Wadsworth Boulevard Widening Value Engineering Study Report

City of Wheat Ridge Public Works

The 3.5-day Value Engineering Workshop was held from April 30th to May 3rd, 2018 at City of Wheat Ridge City Hall located at 7500 W 29th Ave, Wheat Ridge, CO 80033. The VE Study was undertaken in accordance with the Colorado Department of Transportation (CDOT) Value Engineering Guidelines as well as the SAVE International Value Engineering Job Plan, which includes three stages: (1) Pre-Workshop, (2) Workshop, and (3) Post-Workshop.

| VE PROPOSAL VE-16 | |
|--|--|
| DESCRIPTION OF VE PROPOSAL: Use existing outlet in Johnson Park with water quality vault | Page No. 2 of 2 Prepared By: Gary Huber |

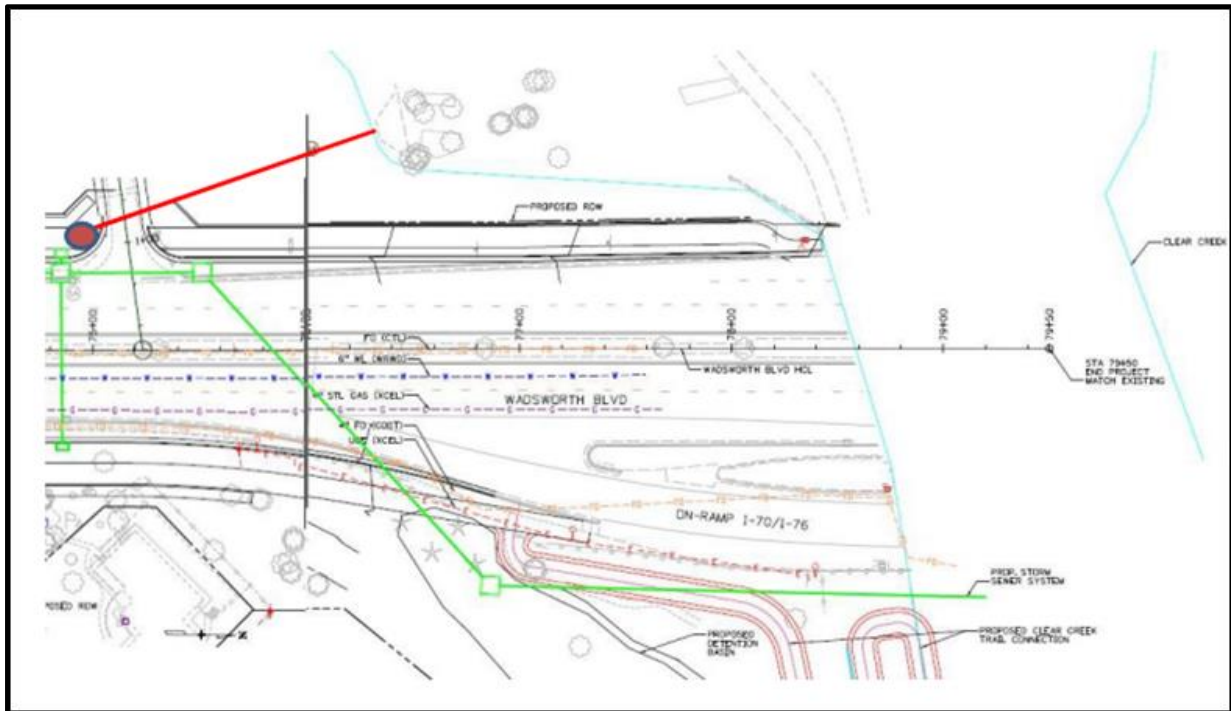
Plans show all storm water goes under Wadsworth at the north end of project and into a water quality pond, then to Clear Creek drainage. The existing drainage outfalls into Johnson Park, which is 4F land.

| VE PROPOSAL VE-17 | |

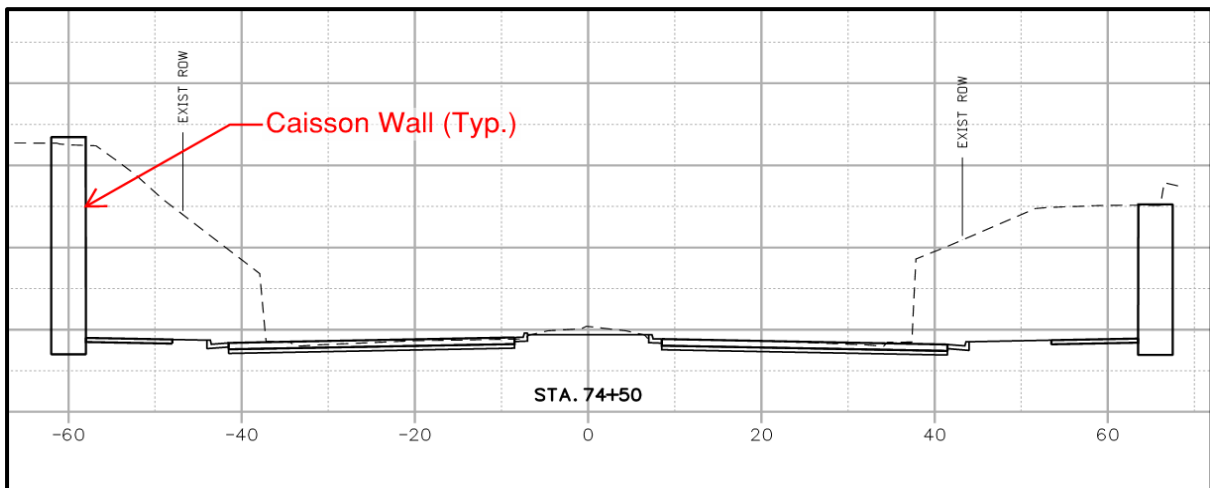
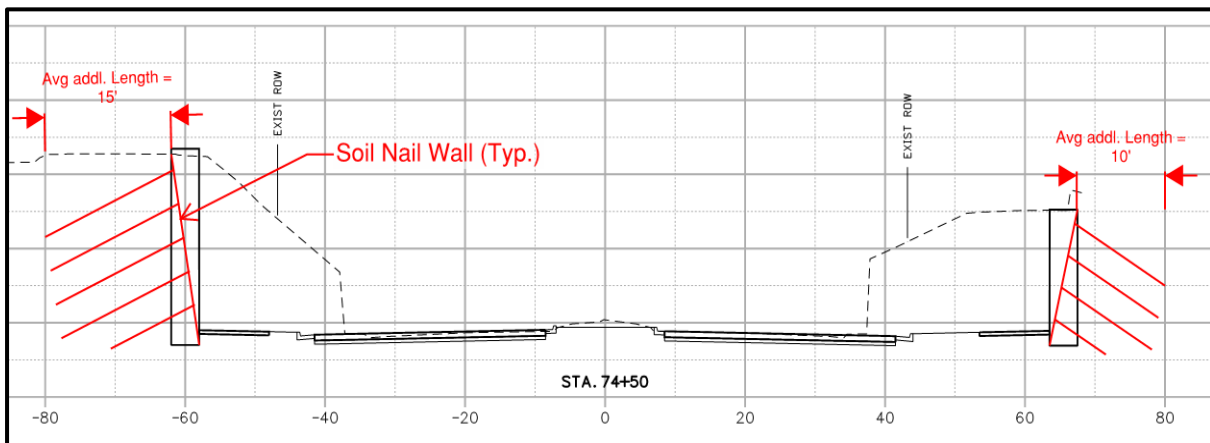
| SUMMARY OF COST ANALYSIS | |
|---------------------------------|--------------------------|
| ESTIMATED SAVINGS | \$70,000 |

| VE PROPOSAL VE-18 | |
|---|---|
| DESCRIPTION OF VE PROPOSAL: Use off-ramp from Wadsworth onto 48th and eliminate the frontage road | Page No. 2 of 3 Prepared By: Darin Freeman/ Steve McQuilkin |

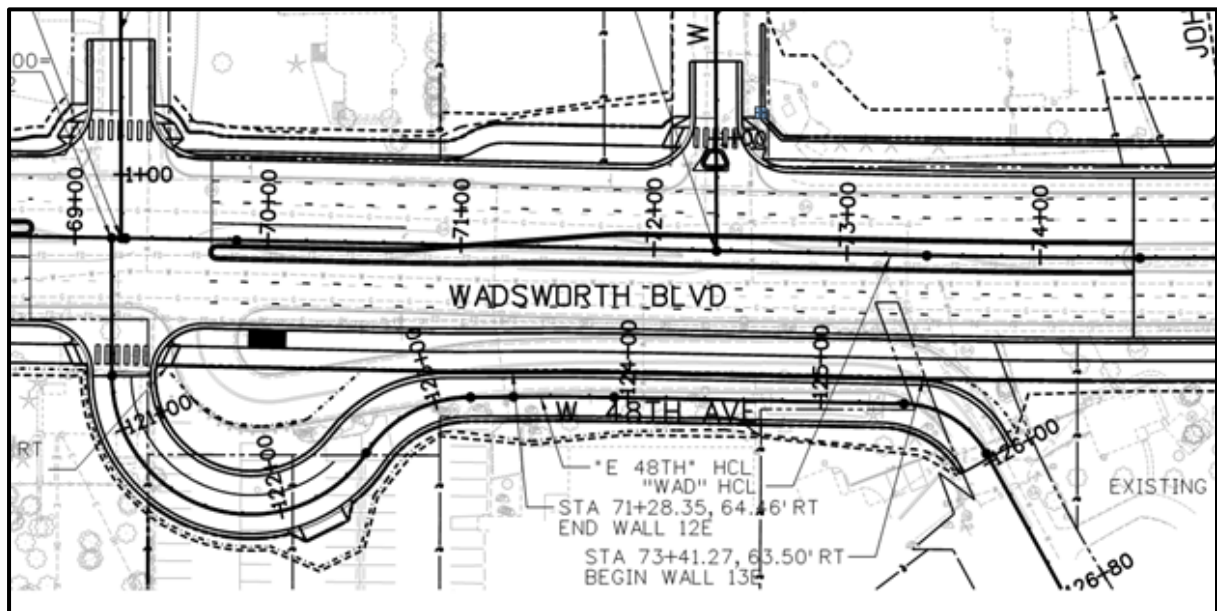
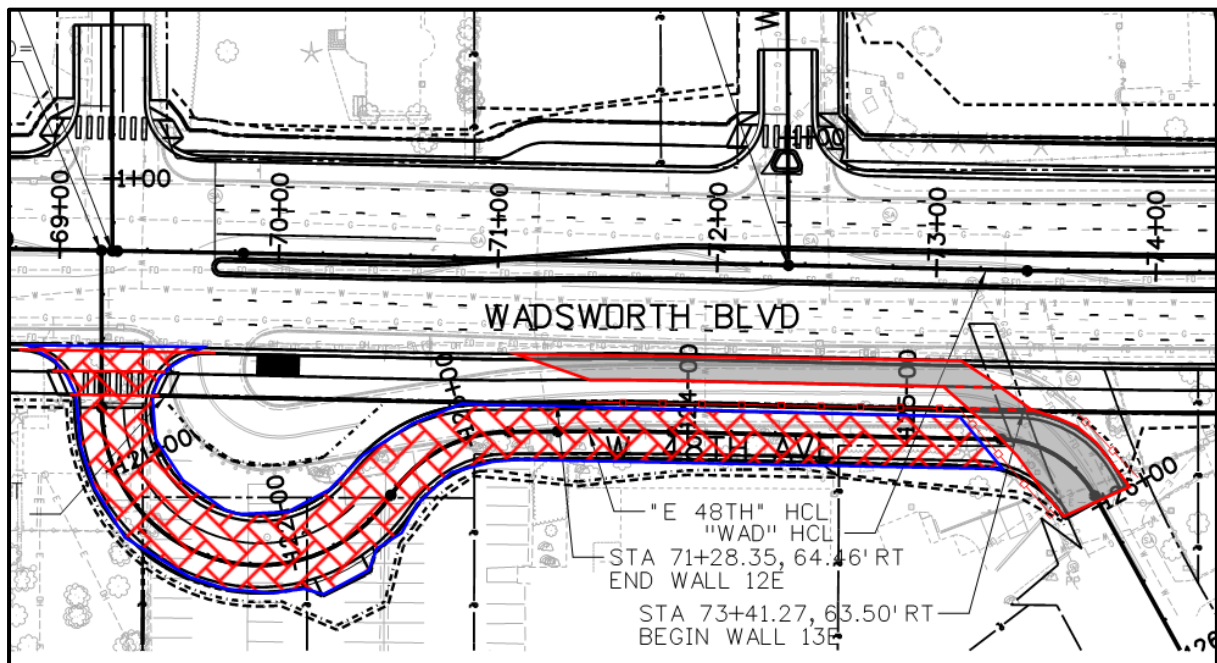
- Might be difficult to match grades going from 48th onto Wadsworth. May need some small retaining walls to build grade on 48th Ave;
- Those who want to access Wadsworth from 48th will have to go a longer route through the neighbourhood to the east. This modification severely impacts access to and from the 4800 building;
- Those heading SB on Wadsworth will need to U-turn at 47th Ave to access this property; and,
- Introduces the possibility of a wrong way entry going SB in the NB lanes.

| VE PROPOSAL VE-19 | |

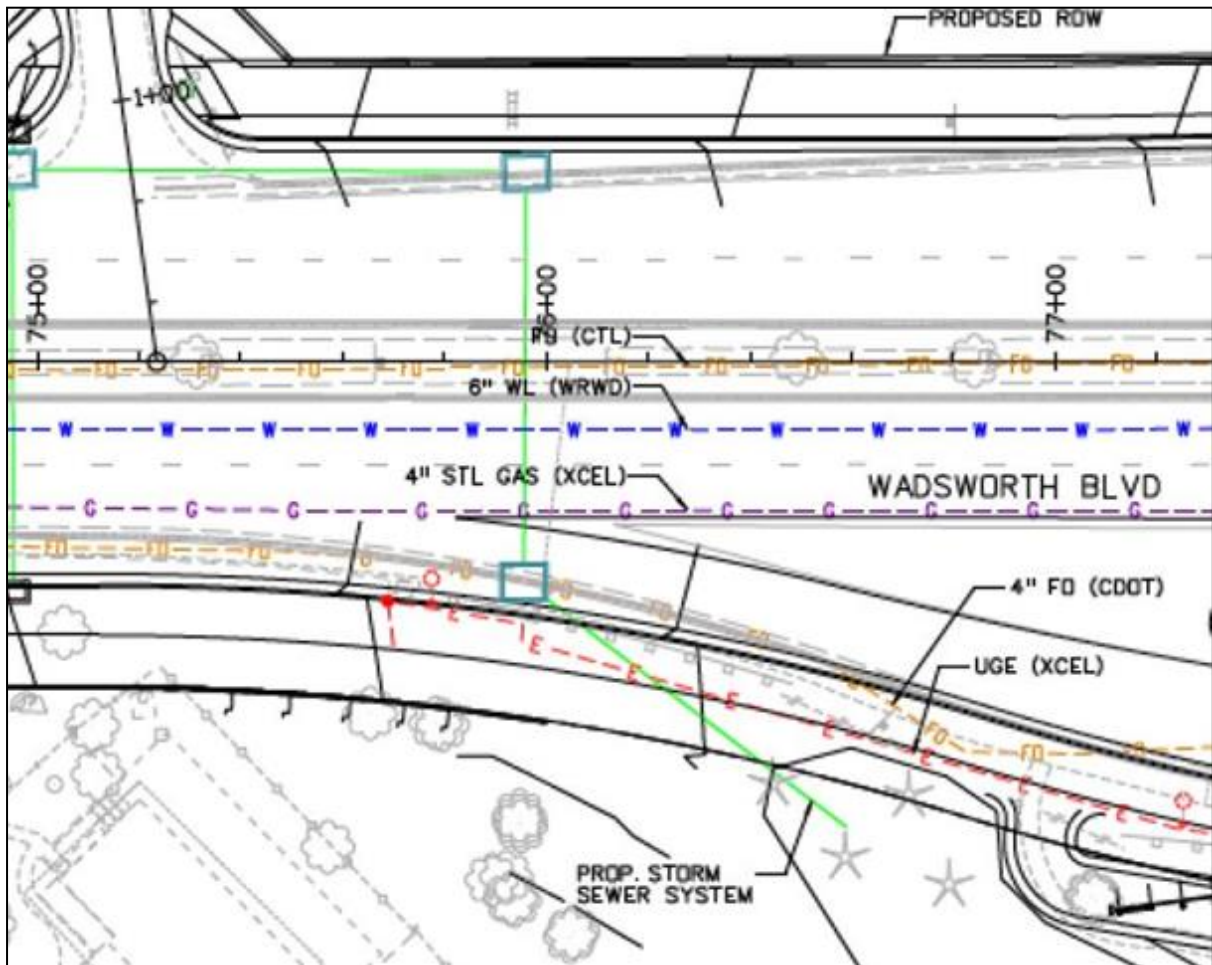
Plans show all stormwater going under Wadsworth at the north end of project and into a water quality pond, then to Clear Creek drainage. The existing drainage outfalls into Johnson Park, which is 4F land.

Manhole at Sta 74+95 Lt is the splitter box. Don't know where the existing manhole is.

| DESIGN COMMENT DC-6 | |
|--|--|
| DESCRIPTION OF DESIGN COMMENT: Eliminate the right-in-right-out for the new development on the west side of the corridor | Page No. 2 of 2 Prepared By: Russ Higgins |

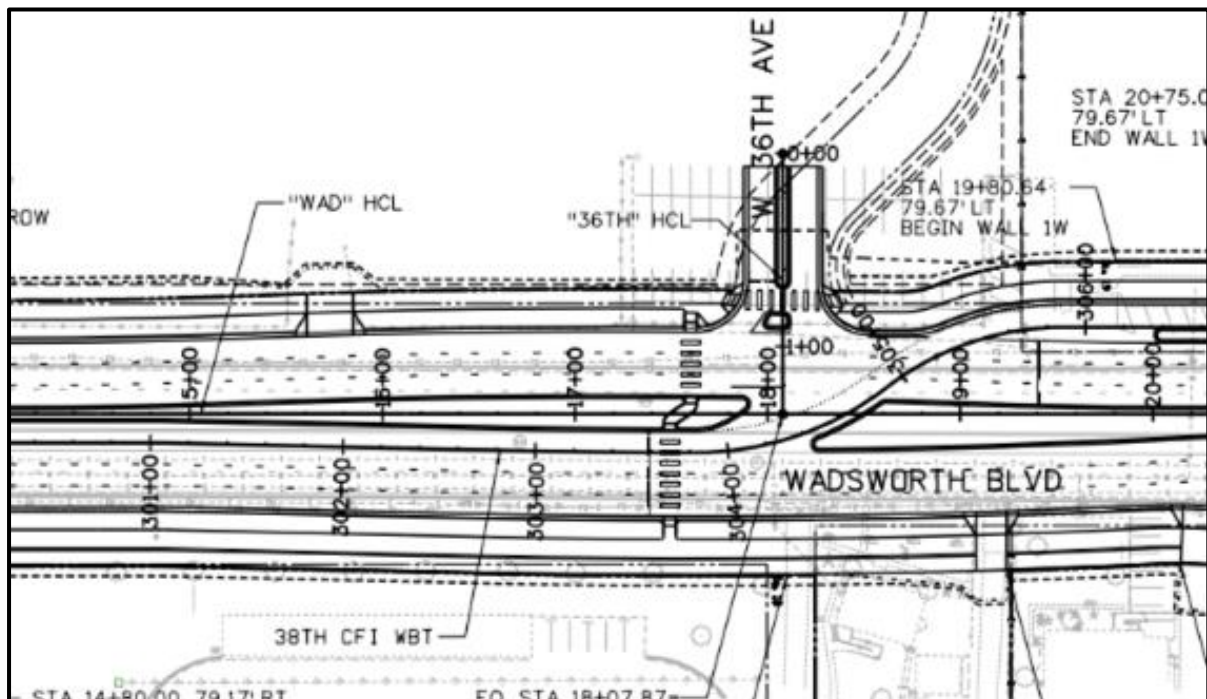
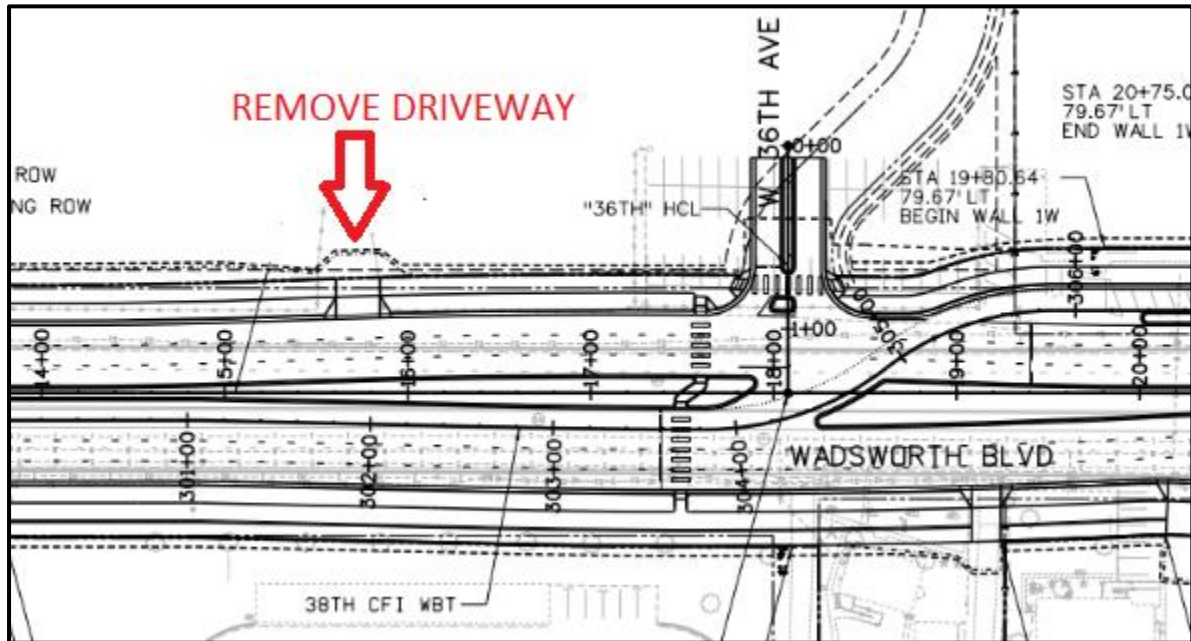
| DESIGN COMMENT DC-6 | |
|--|--|
| DESCRIPTION OF DESIGN COMMENT: Eliminate the right-in-right-out for the new development on the west side of the corridor | Page No. 1 of 2 Prepared By: Russ Higgins |

- Reduces conflict points on Wadsworth to improve safety

| DESIGN COMMENT DC-9 | |
|--|--|
| DESCRIPTION OF DESIGN COMMENT: On south 38 th , extend the median to cover the right-in right-out | Page No. 1 of 1 Prepared By: Gary Huber |

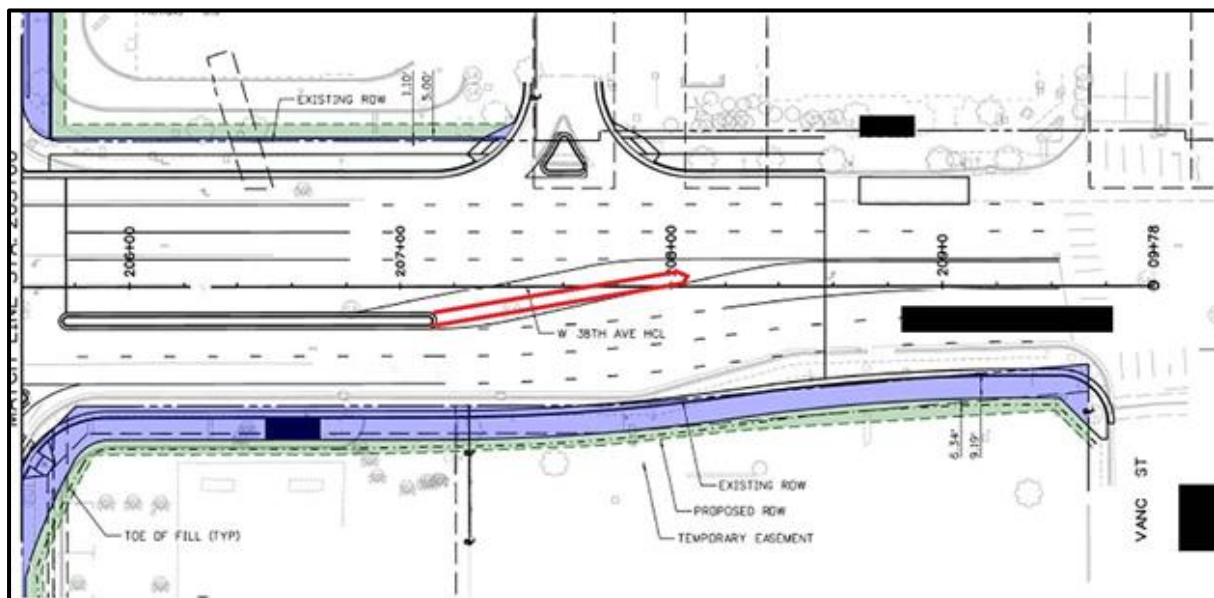
- Safer to not allow vehicles to make a left into this right-in-right-out driveway;
- There is a full access intersection directly to the east; and,
- Also prevents right-out turns from behind Burger King from making a left onto 38th.

| DESIGN COMMENT DC-11 | |
|---|--|
| DESCRIPTION OF DESIGN COMMENT: Right-in only at the dental office | Page No. 2 of 2 Prepared By: Russ Higgins |

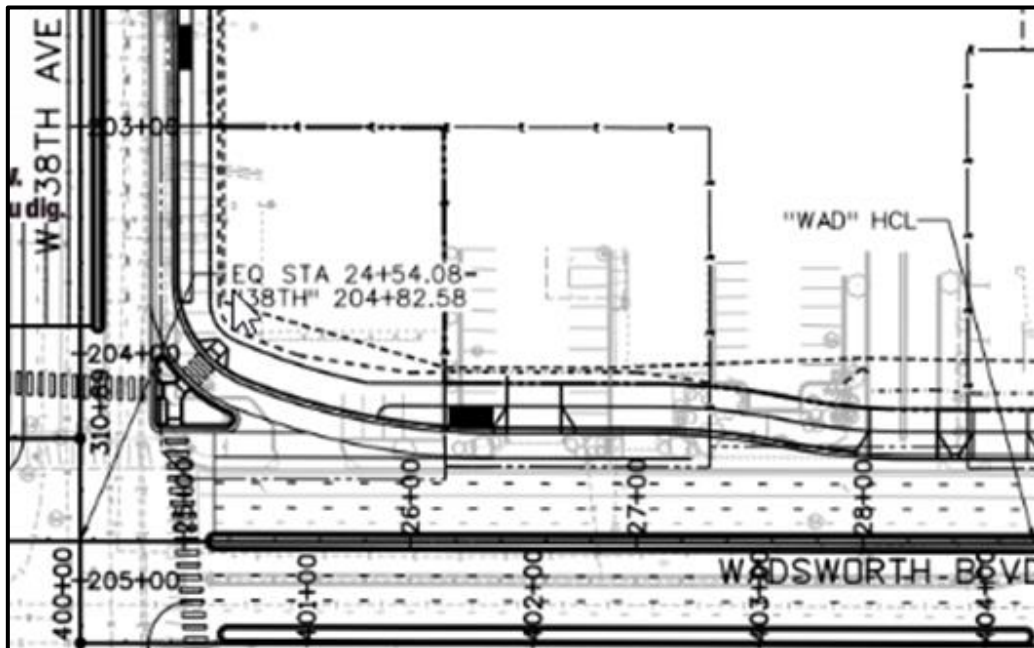
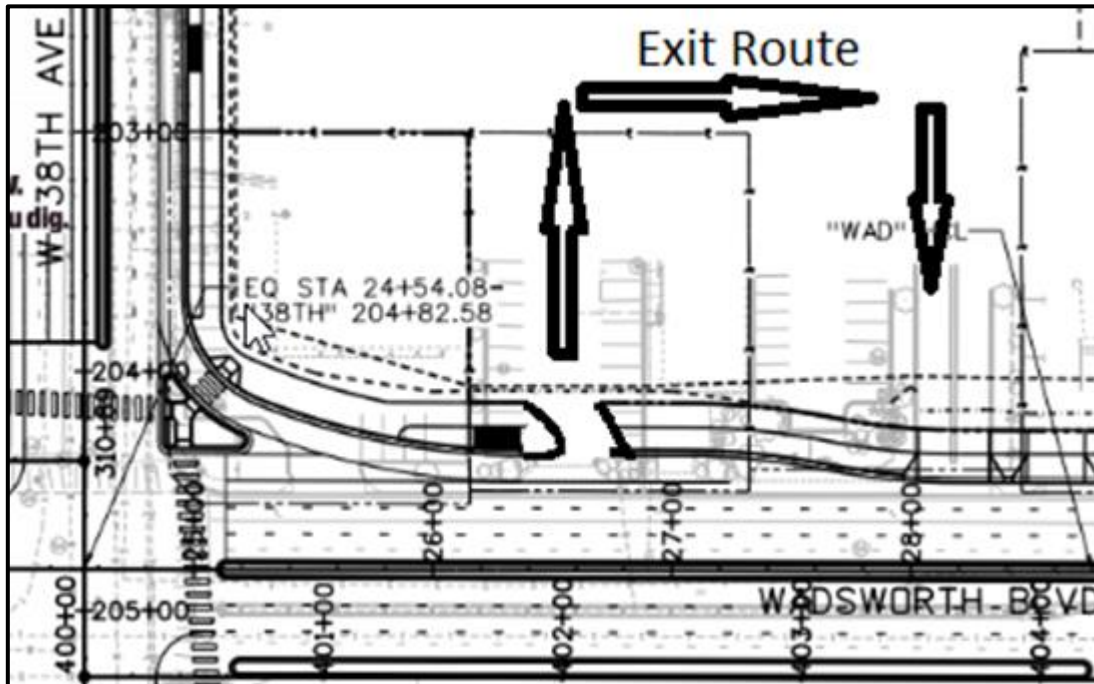
| DESIGN COMMENT DC-11 | |
|---|--|
| DESCRIPTION OF DESIGN COMMENT: Right-in only at the dental office | Page No. 1 of 2 Prepared By: Russ Higgins |

Change the driveway to a right in only

| DESIGN COMMENT DC-12 | |
|--|--|
| DESCRIPTION OF DESIGN COMMENT: Consolidate the two adjacent driveways on the west side of the corridor | Page No. 1 of 1 Prepared By: Russ Higgins |

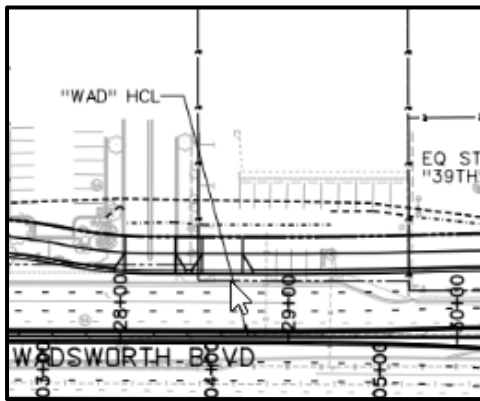
A driveway can be provided from the main driveway to the shopping center to provide ingress and egress to the Mini mall. A second access is at the rear of the property.

| DESIGN COMMENT DC-14 | |
|--|--|
| DESCRIPTION OF DESIGN COMMENT: Extend CFI median south and modify the driveway | Page No. 1 of 1 Prepared By: Russ Higgins |

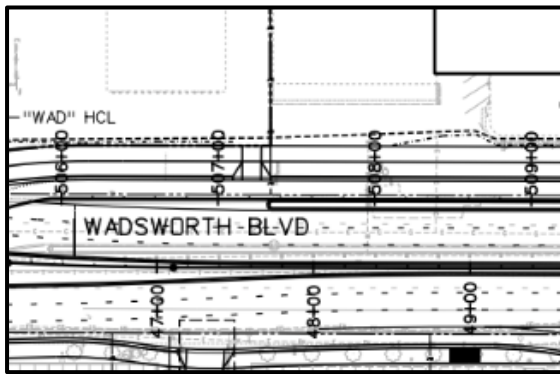
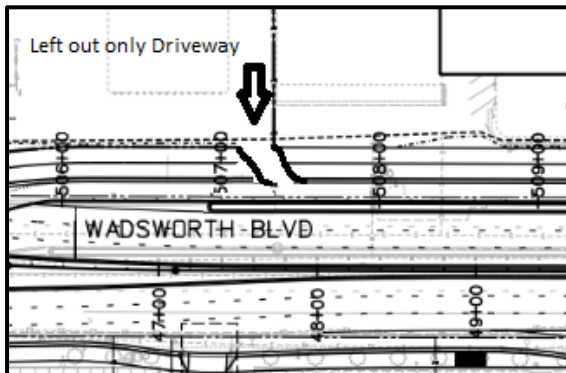
Provide a left turn out only and extend the CFI median.

| DESIGN COMMENT DC-18 | |
|--|--|
| DESCRIPTION OF DESIGN COMMENT: Use the existing north access for Red Lobster | Page No. 1 of 1 Prepared By: Russ Higgins |

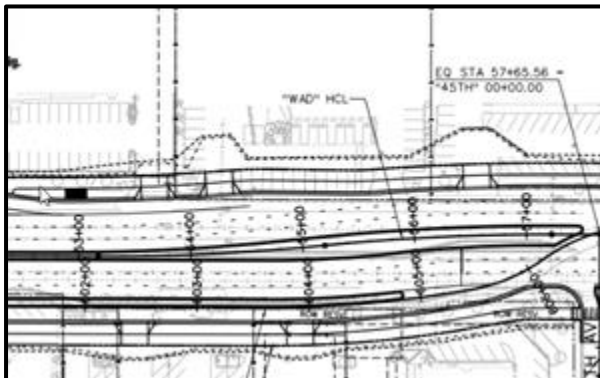
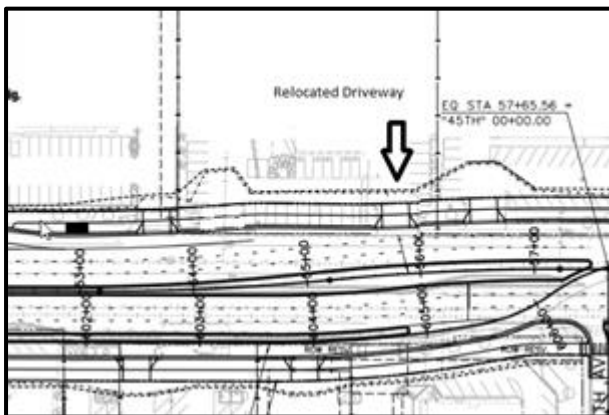
- The driveway is moved out of the exclusive right turn lane.

| DESIGN COMMENT DC-19 | |
|---|--|
| DESCRIPTION OF DESIGN COMMENT: Eliminate Discount Tires access on Wadsworth | Page No. 1 of 1 Prepared By: Russ Higgins |

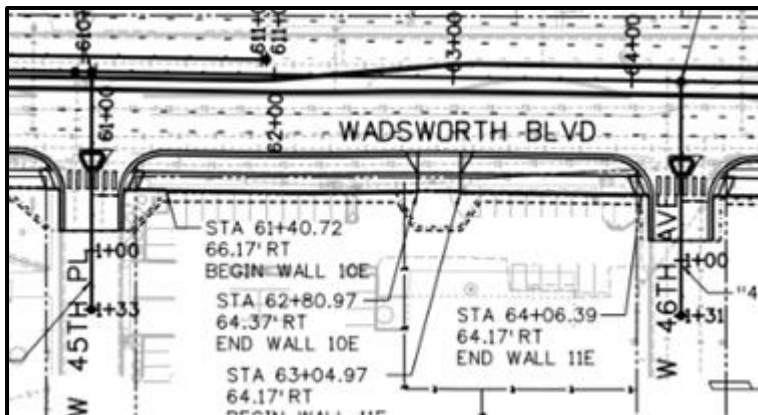
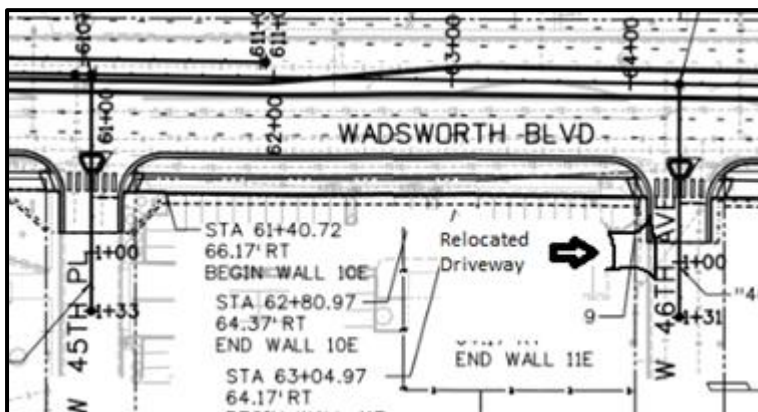
- Eliminating the driveway removes a conflict point and improves safety; and,
- Provides additional parking for the parking lot.

| DESIGN COMMENT DC-21 | |
|--|---|
| DESCRIPTION OF DESIGN COMMENT: At 47 th , reconfigure to ¾ movements in both directions | Page No. 1 of 1 Prepared By: Paul Scherner |

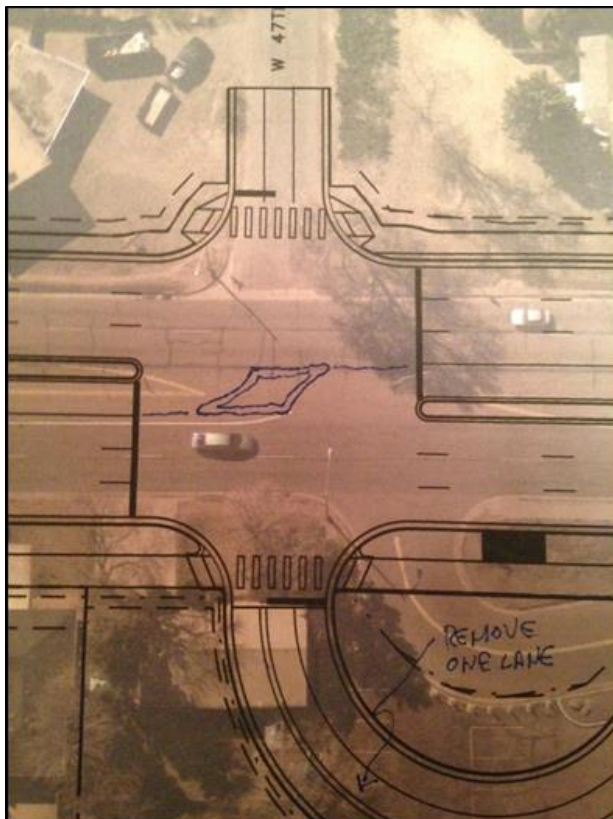
- Improves safety by removing high conflict movements; and,
- Removes one approach lane on the east and west legs of the intersection.
